AMENDMENTS SHOWN IN RED

MODIFICATION)
PROPOSED ALTERATIONS AND ADDITIONS

21 WOORARRA AVE - NORTH NARRABEEN

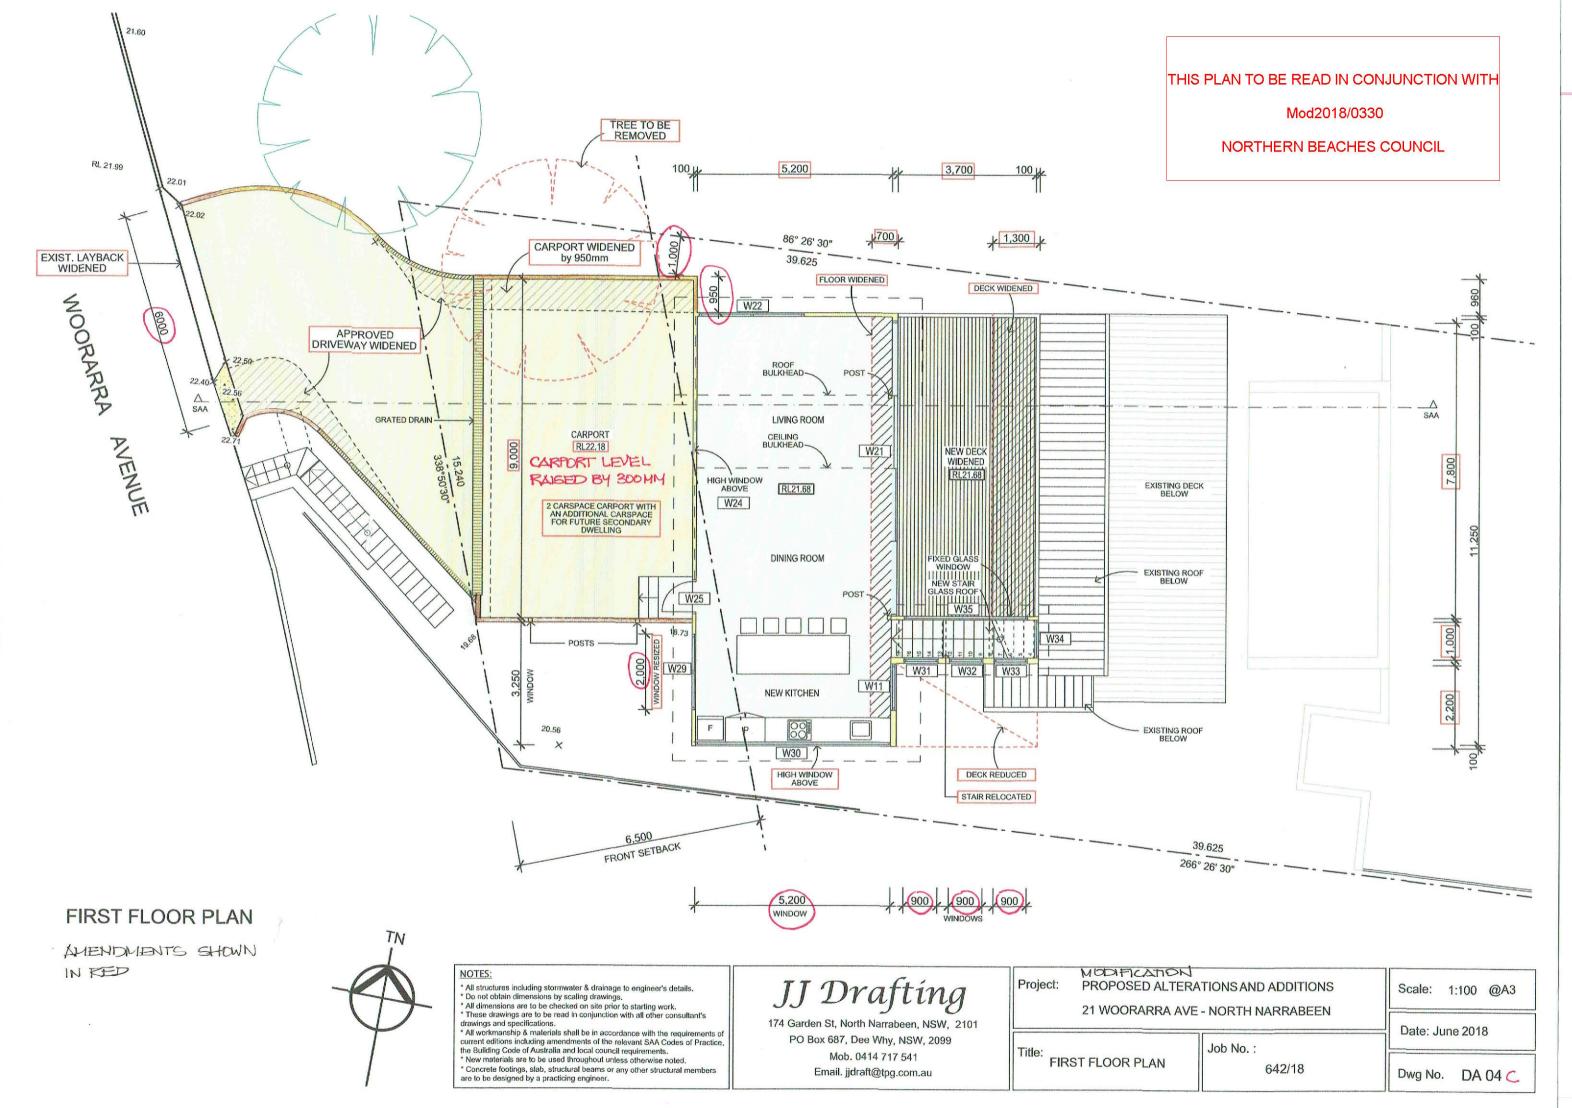
THIS PLAN TO BE READ IN CONJUNCTION WITH Mod2018/0330 NORTHERN BEACHES COUNCIL TREE TO BE REMOVED 17.61 **EXISTING** 86° 26' 30" 22.27 39.625 22.20 HEN WINDOWS 20.09 BEDRROM 01 BEDRROM 03 W13 0 ENSUITE A_ SAA DESIGNED EXIST 19.63 PATIO C !! L 18.57 ENTRY RL18.61 EXISTING DECK NEW POOL BELOW W14 0 RL18.61 19.80 FAMILY RL18,61 13.19 NEW INTERNAL STAIR W15 EXISTING BATHROOM 19,49 BEDRROM 02 NEW WINDOW W26 22.31 18.88 15.16 15.27 900 39.625 WINDOW 266° 26' 30" 16.45 **GROUND FLOOR PLAN** APPROVED ADDITION DELETED 14.26 AMENDMENTS SHOWN IN RED PROPOSED ALTERATIONS AND ADDITIONS JJ Drafting Project: * All structures including stormwater & drainage to engineer's details.

WEST ELEVATION

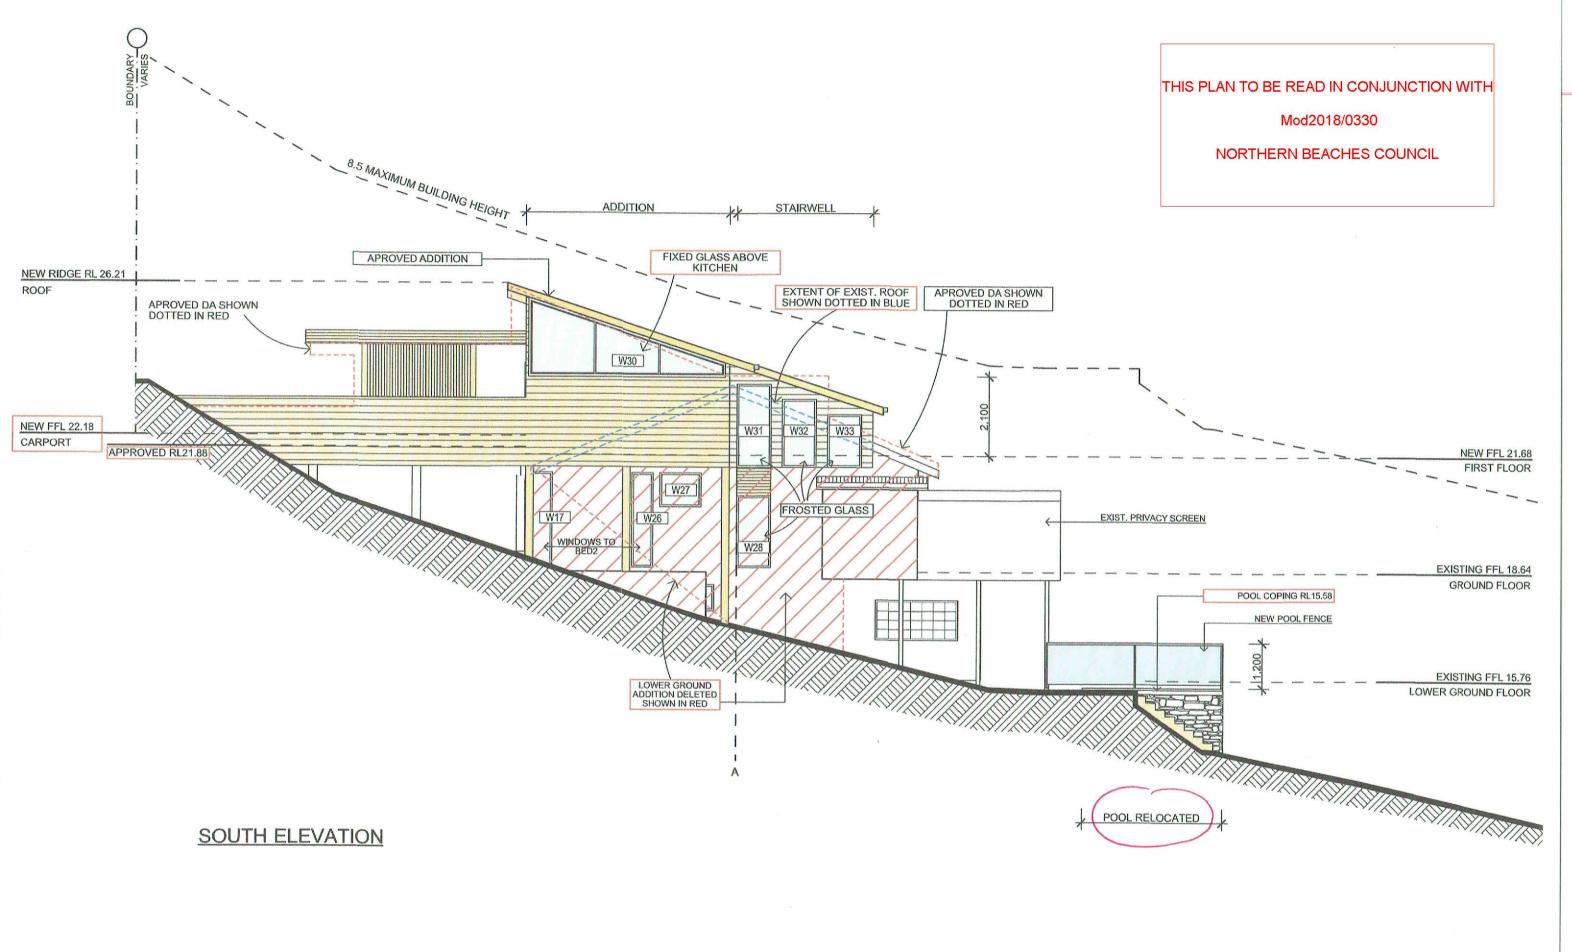
Mod2018/0330 NORTHERN BEACHES COUNCIL APPROVED CARPORT CARPORT WIDENED 8.5 MAXIMUM BUILDING HEIGHT APROVED RIDGE HEIGHT RL26.08 NEW RIDGE HEIGHT RL 26.21 ROOF APROVED DA SHOWN DOTTED IN RED WINDOW W24 RESIZED SHADING CARPORT RAISED BY LINE OF WOORARRA AVE - BEYOND EXTENT OF EXIST. ROOF SHOWN DOTTED IN BLUE WINDOW W29 W25 RESIZED NEW FFL 22.18 CARPORT APROVED DA FFL 21.88 **NEW FFL 21.68** FIRST FLOOR CARPORT **GROUND FLOOR** ADDITION BELOW DELETED W14 W15 W16 EXISTING FFL 18.64 **GROUND FLOOR** *800 ×

WINDOW W16 RESIZED
